MEETING AGENDA

Planning & Zoning Commission

Thursday, January 12, 2023 | 7:00 pm

CASE 1: PZ-22-43 – COLORADO MOUNTAIN SPORTS – 4445 CEMETERY ROAD

EAST ELEVATION OPTIONS

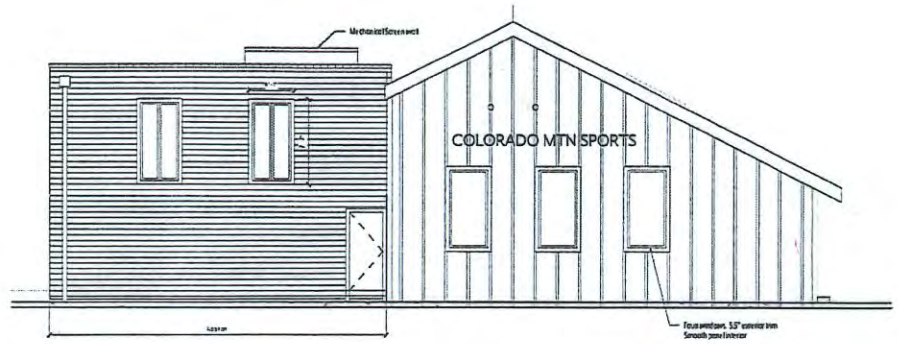
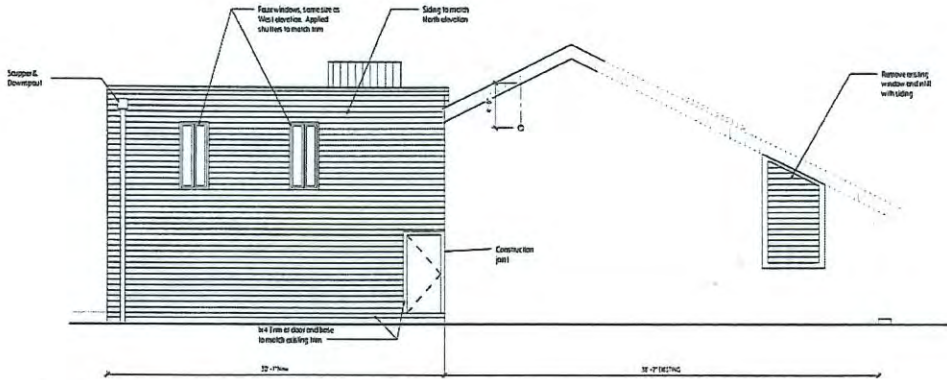
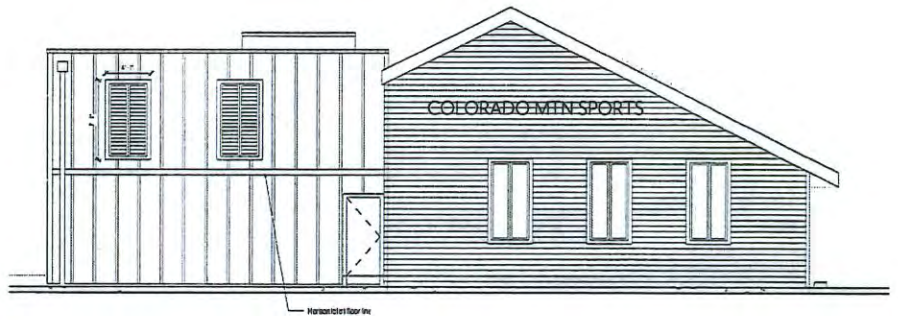
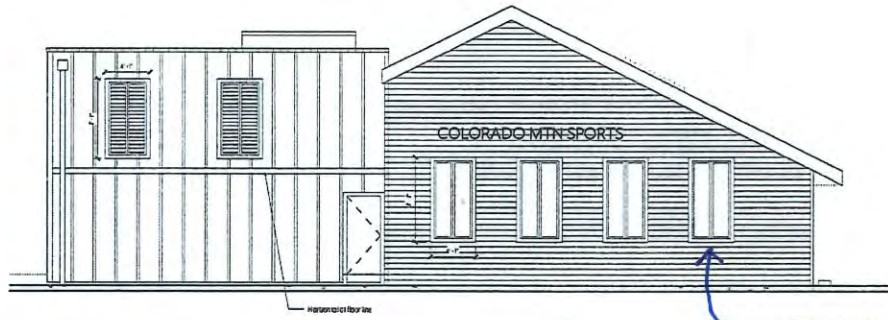
- Proposed architectural elevations show different options for architecture on the east building elevation. Option 3A is preferred and would include horizontal siding with spandrel glass windows to replace the existing stucco. The addition would include faux shutters on the second floor with a board and batten finish. **All final plans must comply with applicable building code and fire code requirements.**

- Proposed architectural elevations show different options for architecture on the east building elevation. Option 3A is preferred and would include horizontal siding with spandrel glass windows to replace the existing stucco. The addition would include faux shutters on the second floor with a board and batten finish. *All final plans must comply with applicable building code and fire code requirements.*

**COLORADO MOUNTAIN SPORTS
 CITY OF HILLARD
 DIMENSIONING AND PAVEMENT PLAN**

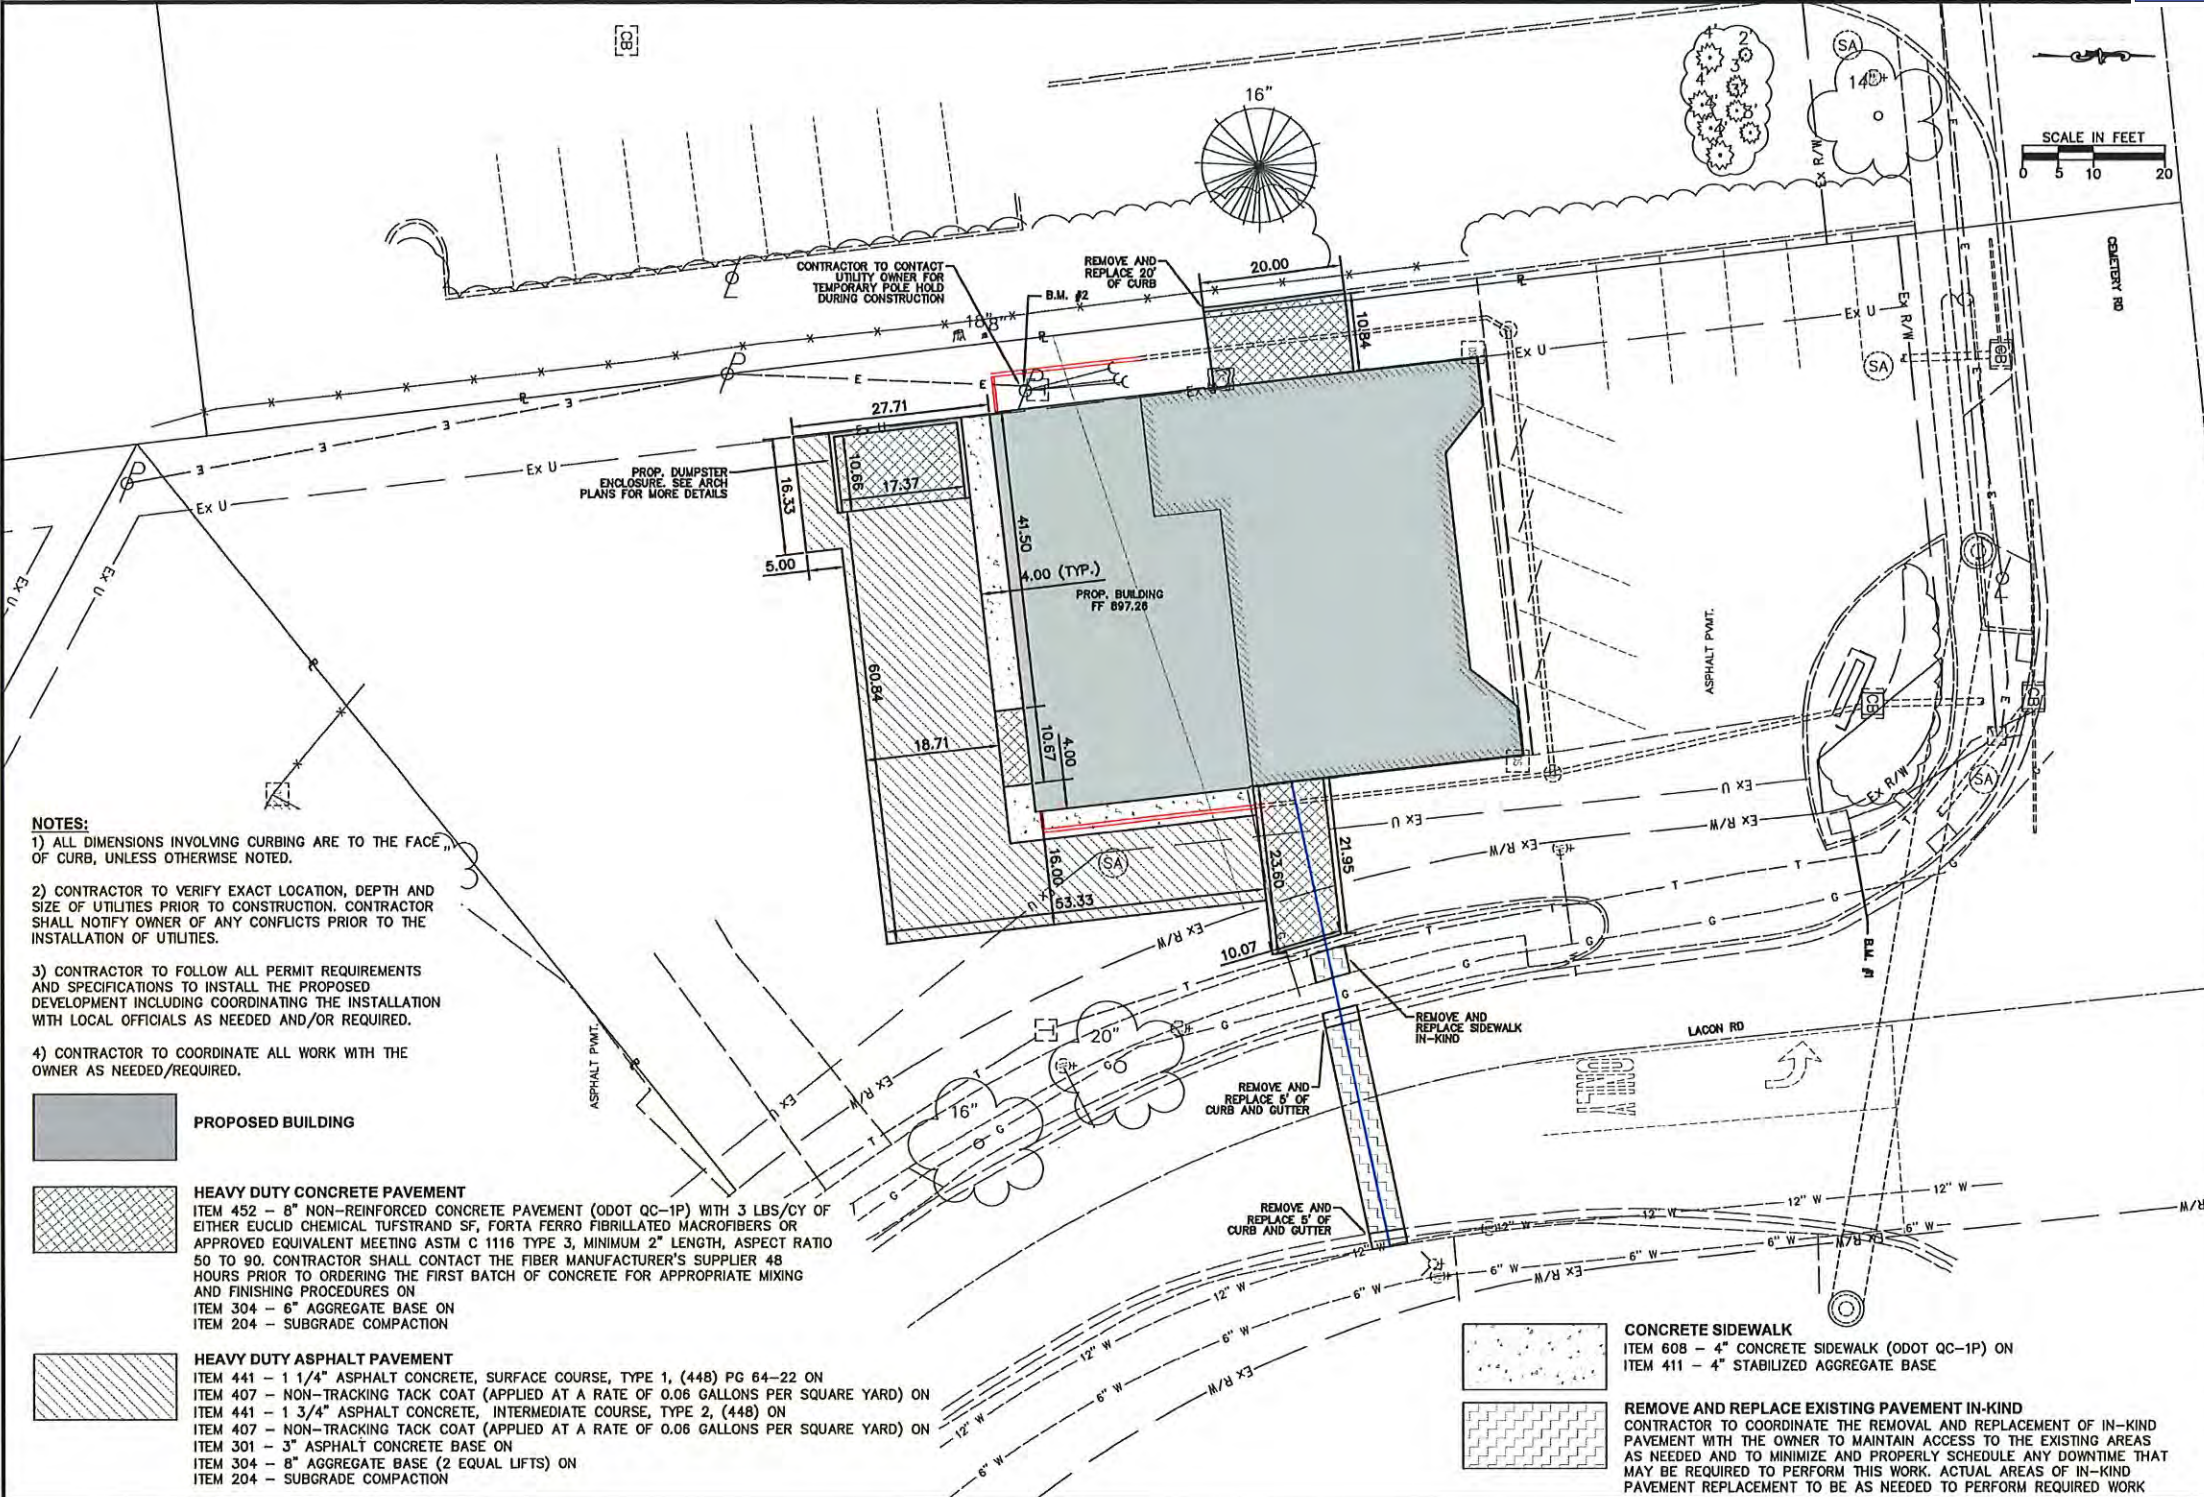
- The proposed plans show a 3,240-square-foot addition to the rear of the building. The plans show a one-way access drive along the east side of the building with egress onto Lacon Road at the south end of the

- The minimum number of required parking spaces is 13 based on the proposed plans. The plans provide the required number of spaces, but spaces for employees will include four double-stacked spaces and one space along the building with restricted access. **The applicant has applied to the Board of Zoning Appeals seeking a variance to approve a comprehensive parking arrangement. The application is scheduled on the December 15, 2020, Board of Zoning Appeals agenda.**

- The proposed plans show a 3,240-square-foot addition to the rear of the building. The plans show a one-way access drive along the east side of the building with egress onto Lacon Road at the south end of the site. *Staff recommends that the southern drive approach be limited to a maximum of 14 feet in width as approved by the City Engineer.*

- The minimum number of required parking spaces is 13 based on the proposed plans. The plans provide the required number of spaces, but spaces for employees will include four double-stacked spaces and one space along the building with restricted access. *The applicant has applied to the Board of Zoning Appeals seeking a variance to approve a comprehensive parking arrangement. The application is scheduled on the December 15, 2020, Board of Zoning Appeals agenda.*
